XT303-S939

TECHNICAL BULLETIN

Thermostat Housing Hose –
Install Additional Hose Clamp –
Service Action S939

MODEL 2002-03 MY
X-TYPE

ILLUSTRATION 1

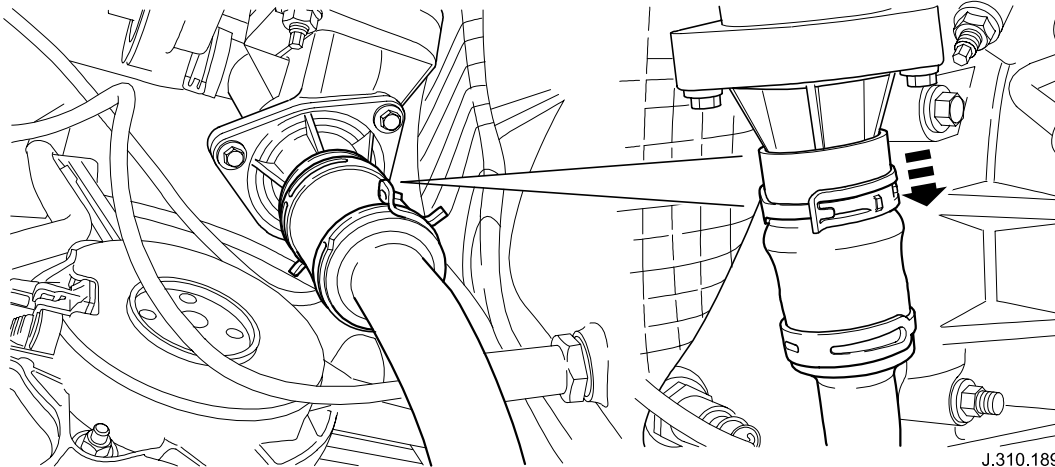
3. Reposition the hose fully upwards to abut the thermostat housing webs.
4. Reposition the spring band clamp close to the bulge in the hose formed by the bead of the thermostat spigot. Illustration 1.

Note: Spring band clamp to be close to, but not on the hose bulge.

ILLUSTRATION 2

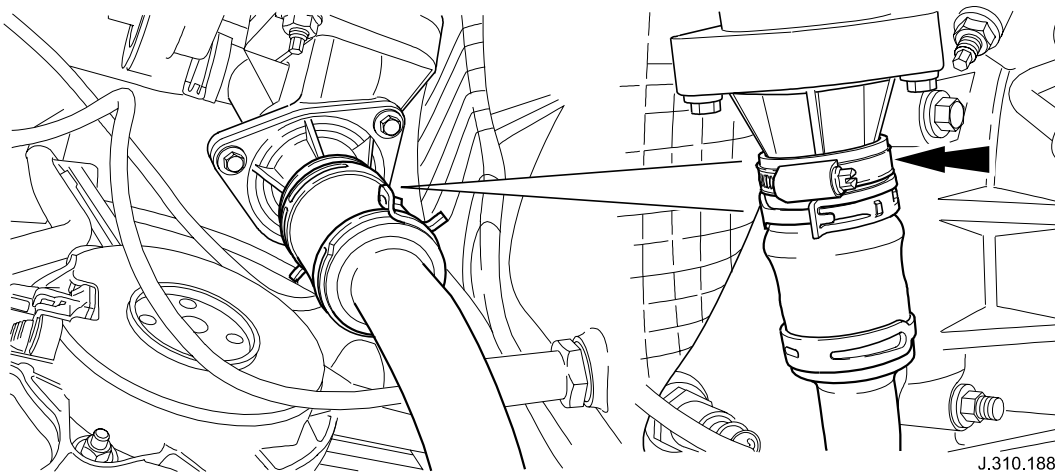
5. Fit an extra 9 mm wide, 32-50 mm Norma worm drive clamp above the existing spring band clamp and tighten to 4.1 Nm +/- 0.7 Nm tolerance. See Illustration 2.

Note: Fit worm drive clamp against the spring band clamp so that the hose protrudes above the worm drive clamp.
